VE #201205 New Circle Road Rehabilitation and Reconstruction of KY4/US-60 Interchange Projects

Items #7-113.00 & #7-279.00
Fayette County, Kentucky

Value Engineering Study Report

Study Dates: December 10-14, 2012
Final Report Date: Pending

TITLE: Use an integral retaining wall and sound wall design using soldier piles

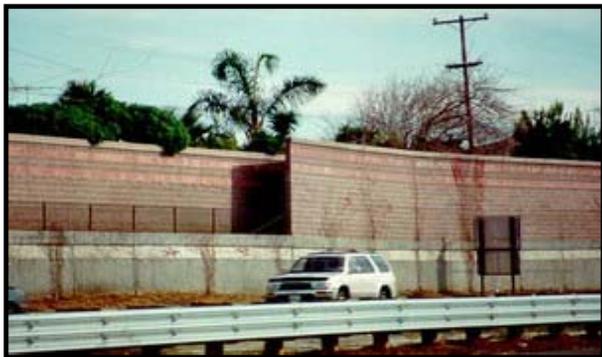
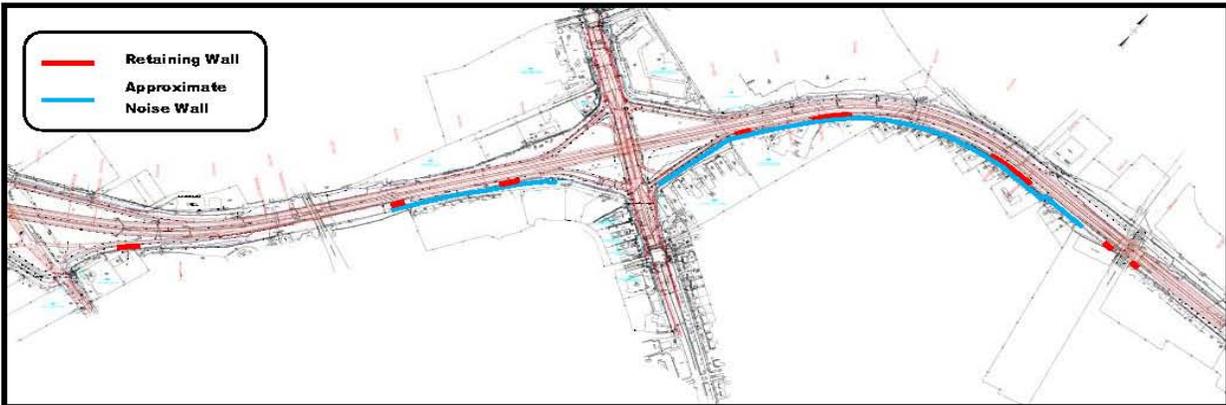
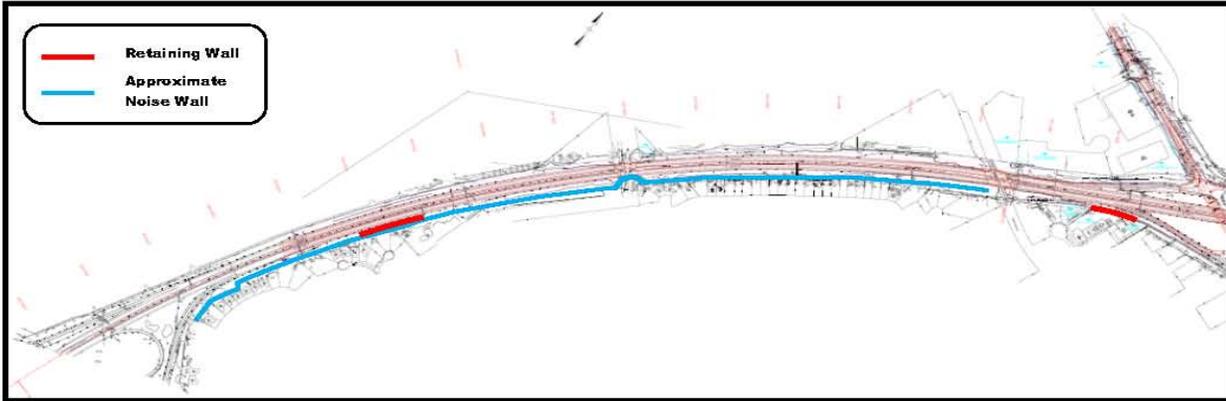
TITLE: Use an integral retaining wall and sound wall design using soldier piles				
FUNCTION:		Retain Earth		
BASELINE ASSUMPTION:				
For the baseline it was assumed that a noise wall averaging 16 ft. in height would be installed near the right-of-way line along the inside of New Circle Road near the dense residential areas. These noise walls would be installed separately of the planned retaining walls that are being used to keep construction within the limits of the existing right-of-way.				
PROPOSED ALTERNATIVE:				
The proposed alternate would integrate the proposed noise walls with the proposed retaining walls in areas where both are needed. Newer construction methods allow retaining wall panels to be slid into place, between piles, under noise wall panels.				
BENEFITS		RISKS/CHALLENGES		
<ul style="list-style-type: none"> Both walls would be integrated, meaning the footings for the retaining wall would not be needed 		<ul style="list-style-type: none"> Costs for this method may be higher than for standard noise walls

TITLE: Reduce lane widths on Leestown Road under New Circle

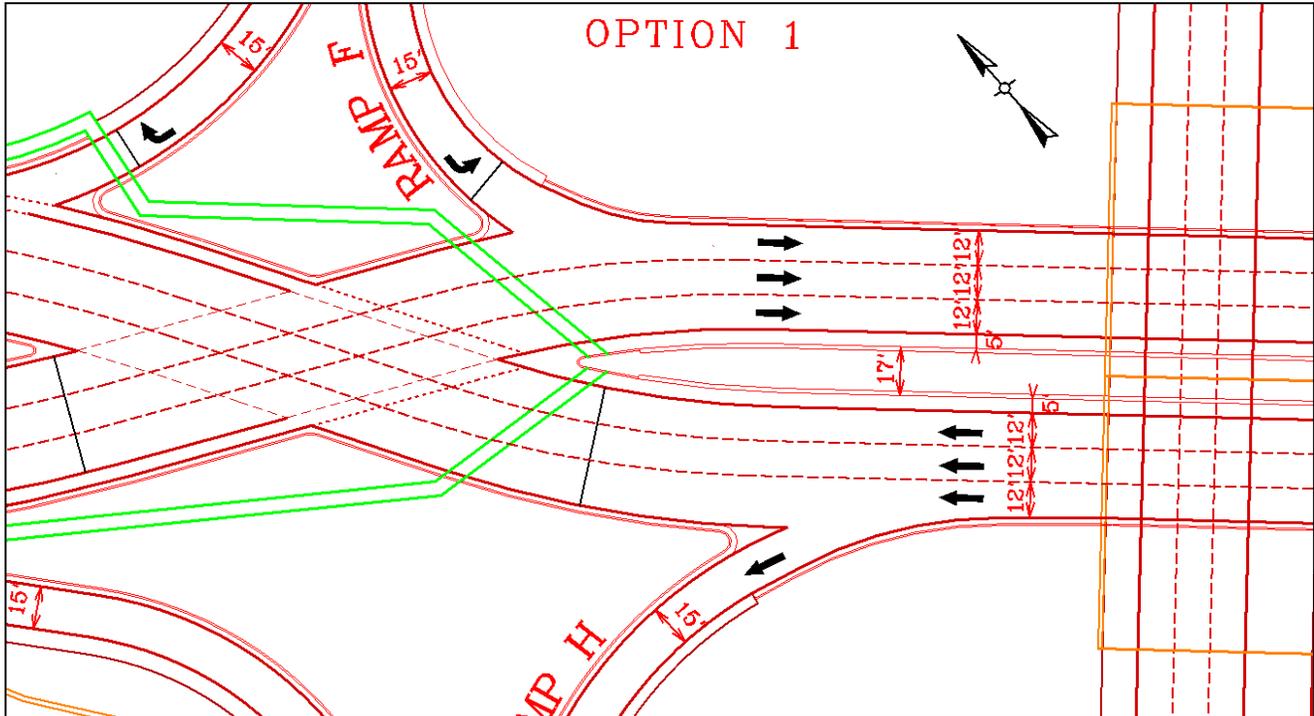
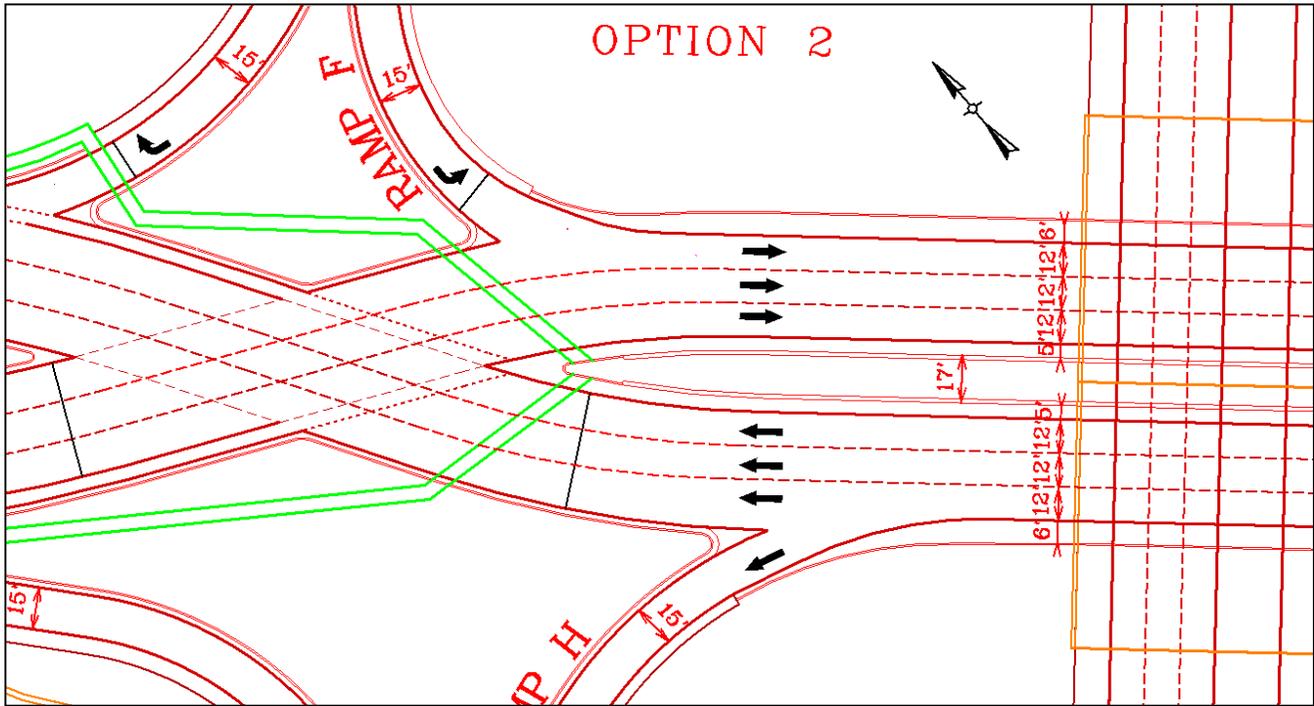
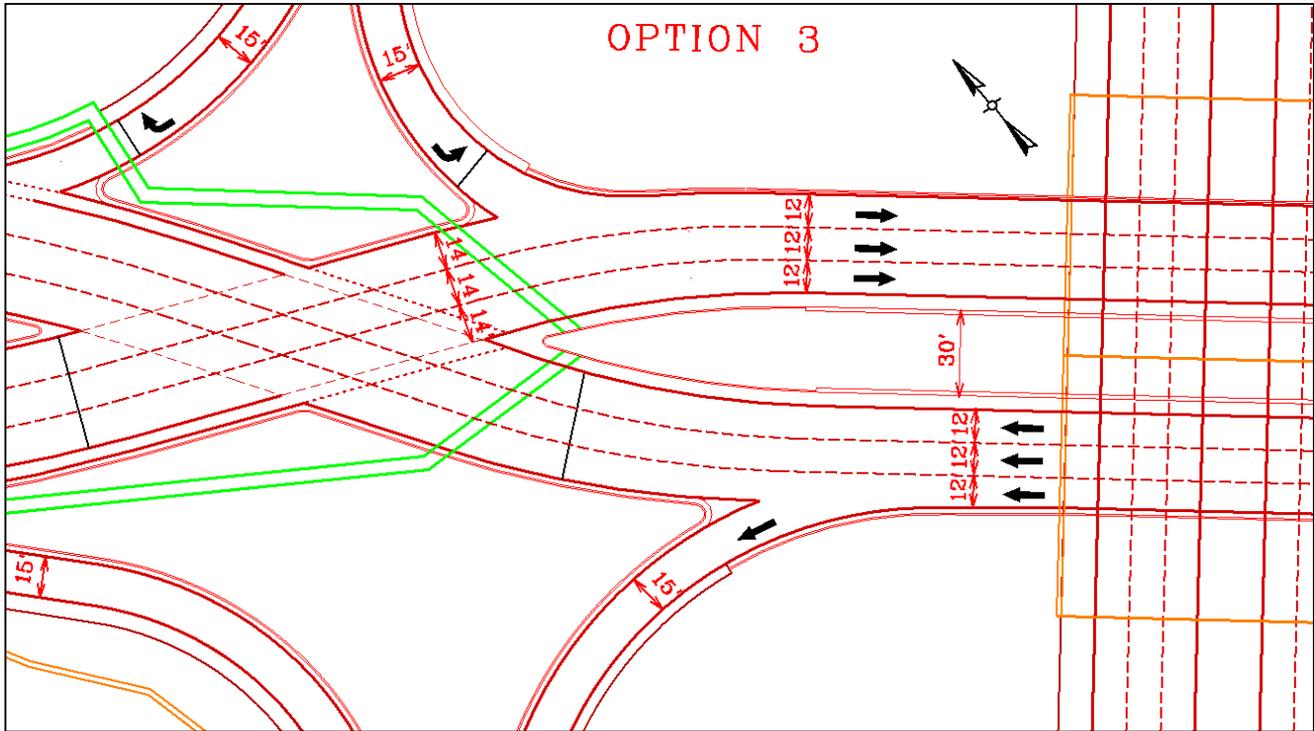
The proposed modification is to transition the 14-ft. wide lanes to 12 ft. beneath New Circle Road. This allows three options for consideration:

1. Move the outside curb and gutter in 6 ft. on each side and maintain a 36-ft. wide traveled way with 2 ft. gutter on the outside and 5-ft. bicycle lane on the inside for a total width of 44 ft.
2. Maintain the outside curb and gutter in the baseline location and provide a 6-ft. outside shoulder on each side. This could assist with future maintenance activities and snow and ice removal.
3. Maintain the outside curb and gutter in the baseline location and provide a wider median and pedestrian facility. As proposed in the baseline condition, the total width of the pedestrian facility in the center of Leestown Road is less than 17 ft. wide. Assuming the proposed bridge carrying New Circle Road over Leestown Road will include a center row of piers, as the existing bridge does, the usable width of the pedestrian facility would be reduced.

TITLE: Reduce Leestown Road to two lanes westbound at the outer loop entrance ramp

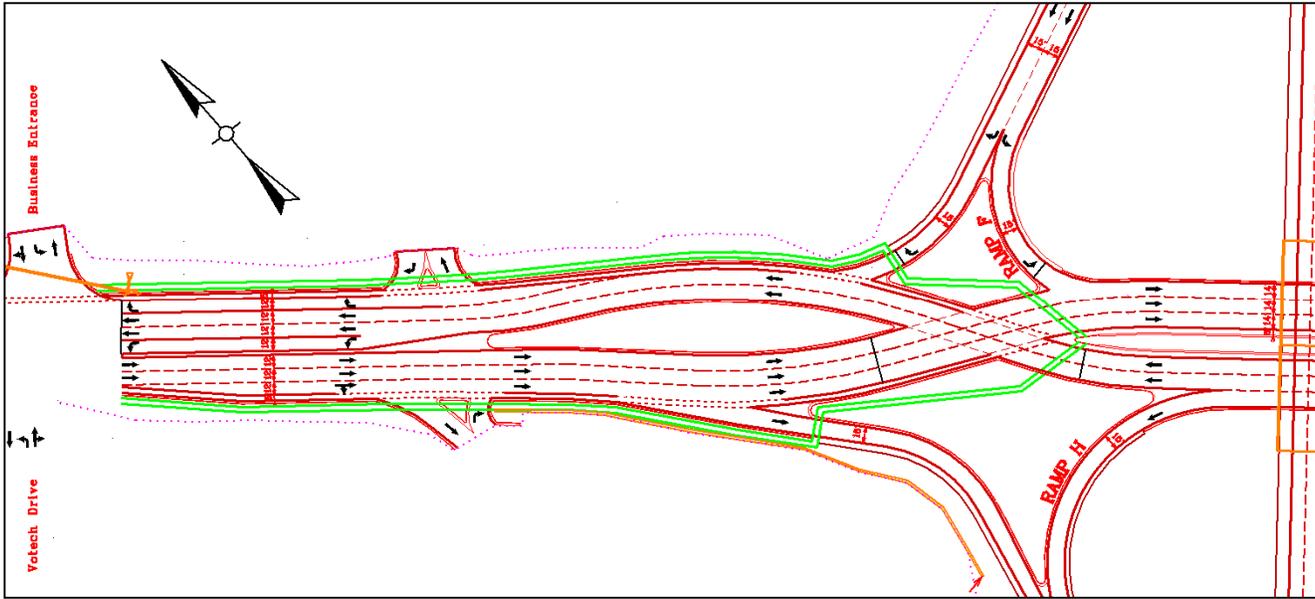
The proposed modification is to drop the left westbound through lane at the outer loop crossover intersection (at Ramp H) as a left turn only for access onto southbound New Circle Road. Two lanes would be carried through the crossover intersection and separate left-turn and right-turn lanes are developed upstream of the Leestown Road intersection with Votek Drive/Business Entrance. This would provide the same capacity at the Votek Drive/Business Entrance intersection.

A cursory evaluation of the outer loop crossover intersection suggests some operational concerns in the 2034 design year PM peak. Therefore, further evaluation would be necessary to determine the viability of the proposed modification. The proposed modification would allow continuing the third westbound through lane with a minor widening of the median.

TITLE: Realign Ramp B further away from Duncan Machinery Drive

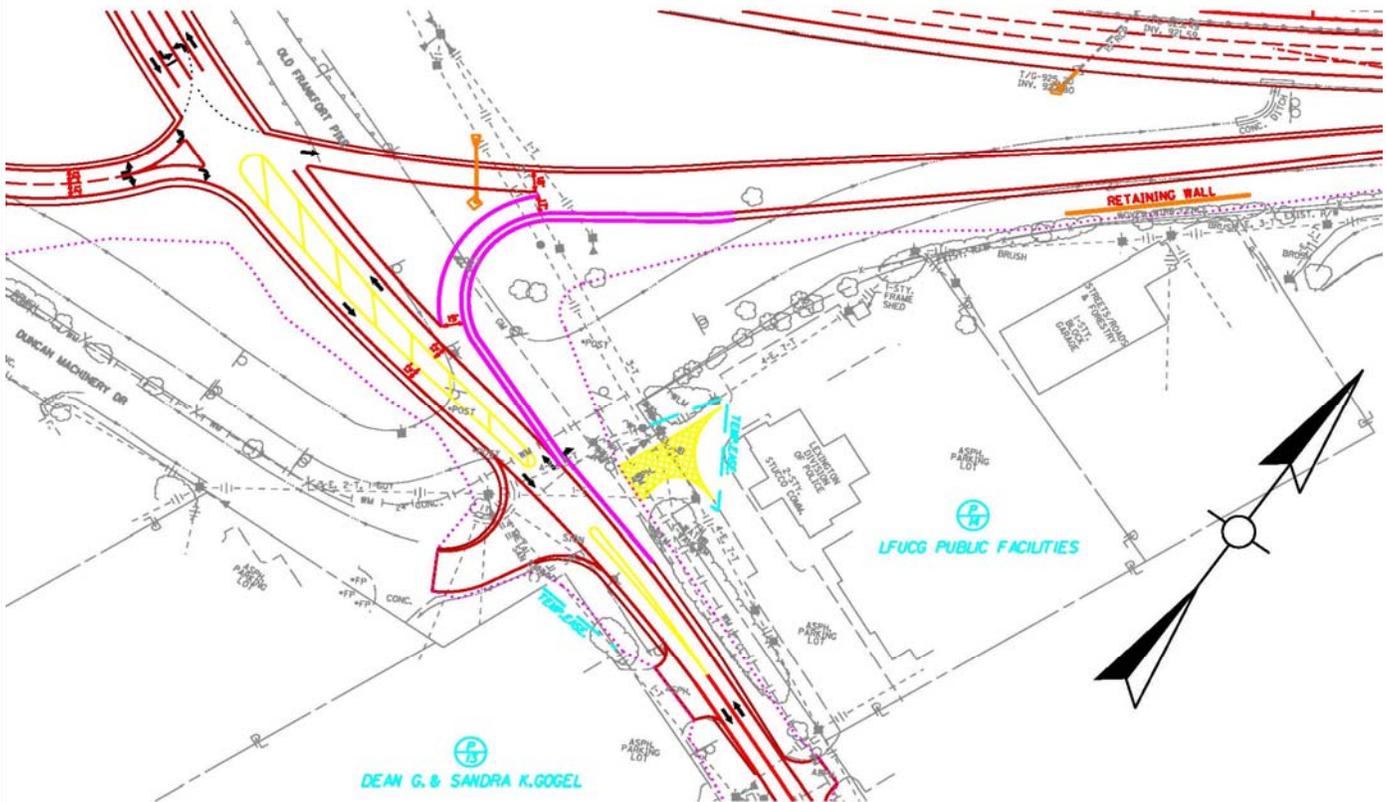
There is a concern with the exiting traffic from Duncan Machinery Drive trying to go northbound on New Circle Road merging with Old Frankfort Pike Road traffic who would be accelerating to get on the ramp. Using the 150-ft. radius creates a free flow right turn that is more rural than urban in character. Since the remainder of the proposed interchange is more urban in nature, this change creates some consistency with the new interchange. Per Green Book, "...close spacing between adjacent ramp terminals and access connections creates operational problems on the crossroad that affect traffic on the ramp..." The revised radius is 75 ft. which is still be acceptable for trucks. The taper will be reduced from 150 ft. to 100 ft.

Stripe a second lane on Old Frankfort Pike Road outside the ramp terminals to feed the left-turn lanes on the bridge over New Circle Road

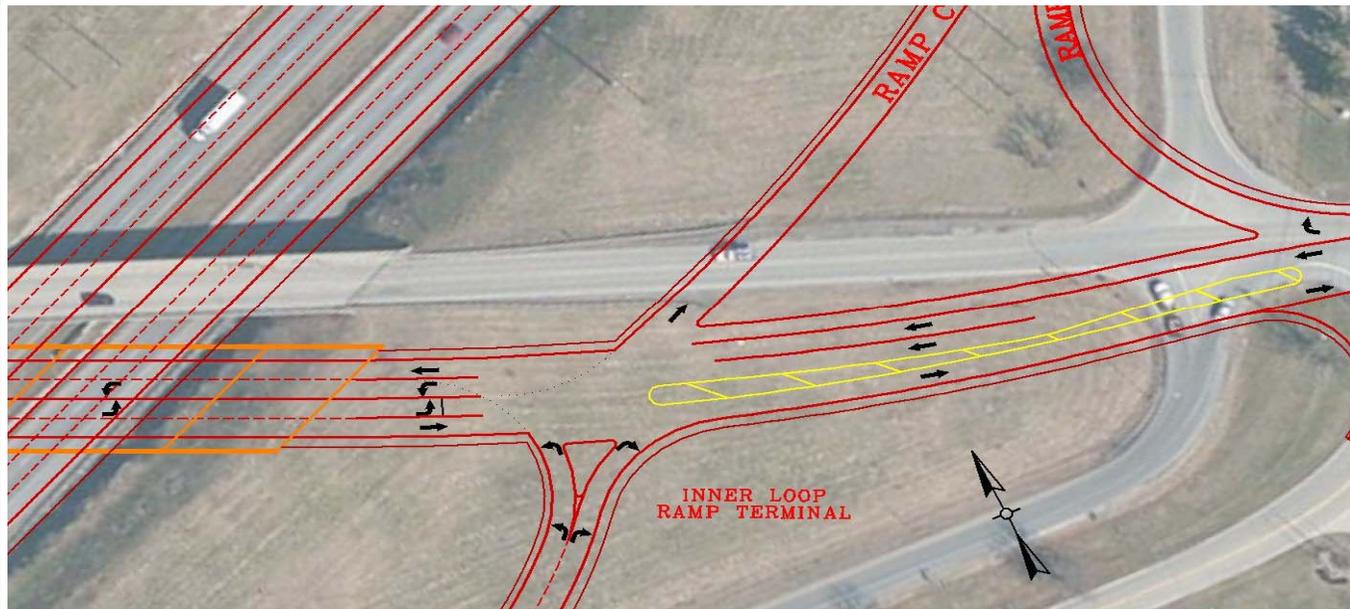
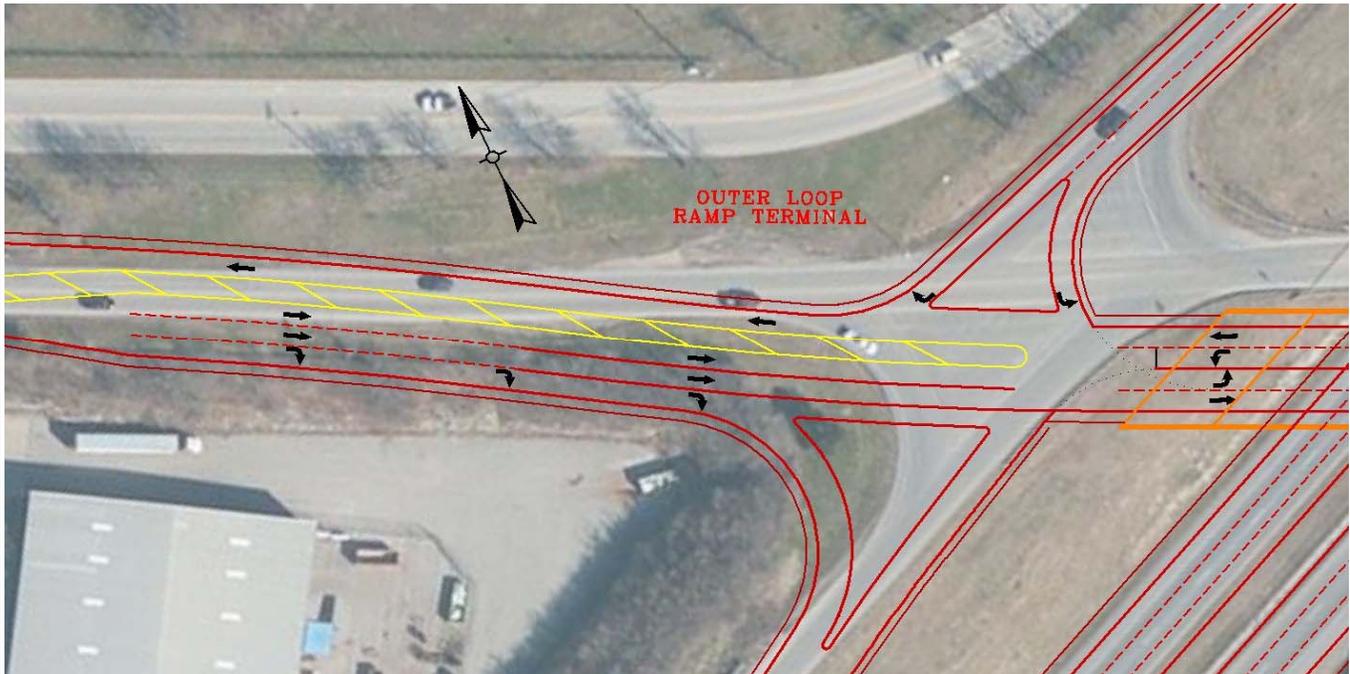
The proposed alternative would provide additional storage for left-turning vehicles outside the New Circle Road ramp terminals by restriping the flush median proposed in the baseline alternative. Over 450' of additional storage can be provided in the eastbound direction and over 200' in the westbound direction. The additional lane will increase throughput and improve operational efficiency of the traffic signals proposed at each ramp terminal. A cursory evaluation of the proposed concept was performed using Synchro Version 7 and found the westbound queue could be reduced by over 50%.

Additional signage will be required to notify drivers that the left-turn lane storage begins upstream of the ramp terminals.

TITLE: Use roundabouts for the Old Frankfort Pike Road interchange

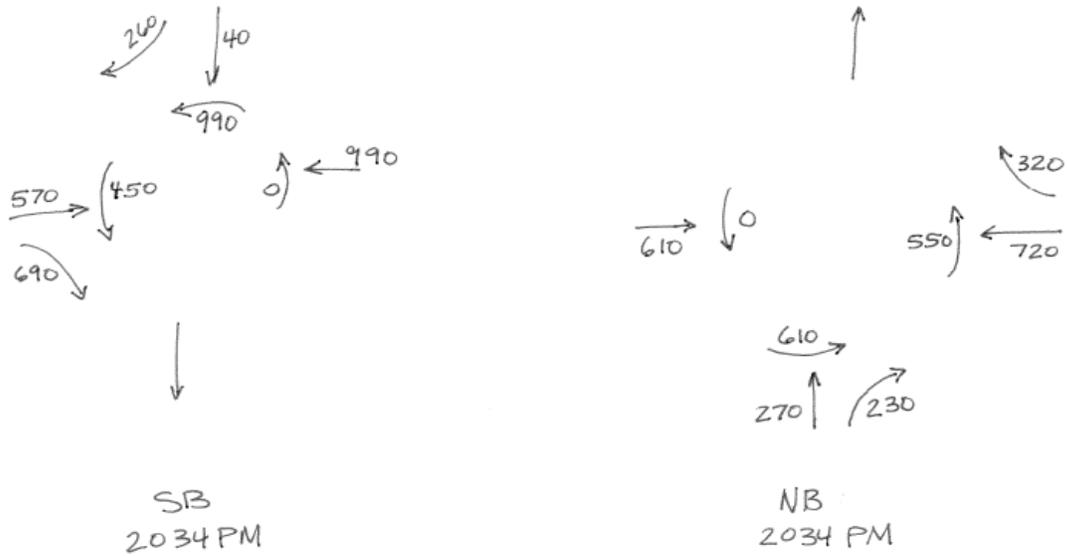
This does very little to change the cost of the project because the bridge would still be four lanes wide and the roundabouts would be approximately in the same location as the proposed conventional intersection. The roundabout inscribed (outside) diameter would be approximately 180 ft. on the northbound terminal and 150 ft. on the southbound terminal.

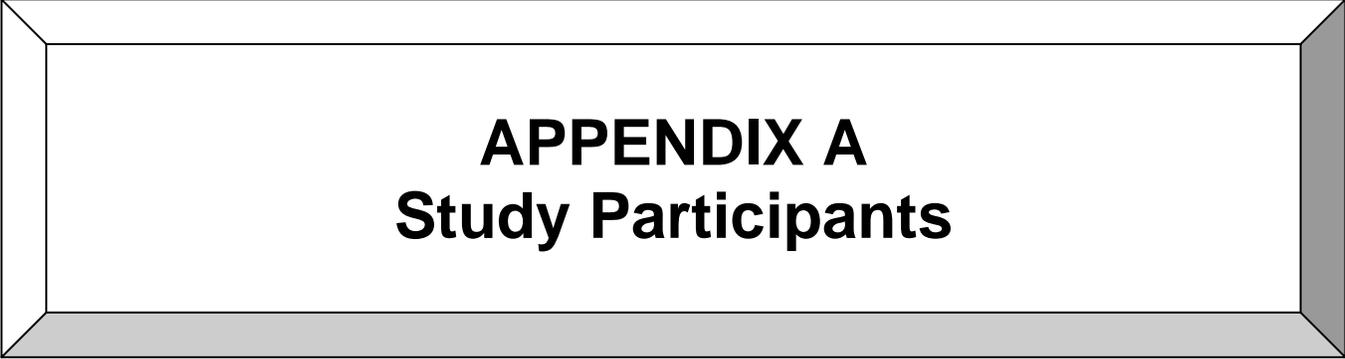
The proposed design suggestion is to utilize high mast lighting at the Old Frankfort Pike Road interchange. High mast lighting typically is 15 to 20 percent less expensive to construct than conventional lighting. Assuming the existing circuitry will be replaced with the project, high mast will be less expensive to install than new conventional lighting. Given the age of the existing wiring and conduit along New Circle Road, that assumption appears reasonable.

High mast lighting simplifies long-term maintenance as lamps can be replaced away from traffic and no specialized equipment is required. Conventional lighting would require the use of a bucket truck occupying the shoulder in order to replace lamps, potentially requiring lane closures.

The use of 80' high mast poles with full cut-off optics can minimize adverse public reaction.
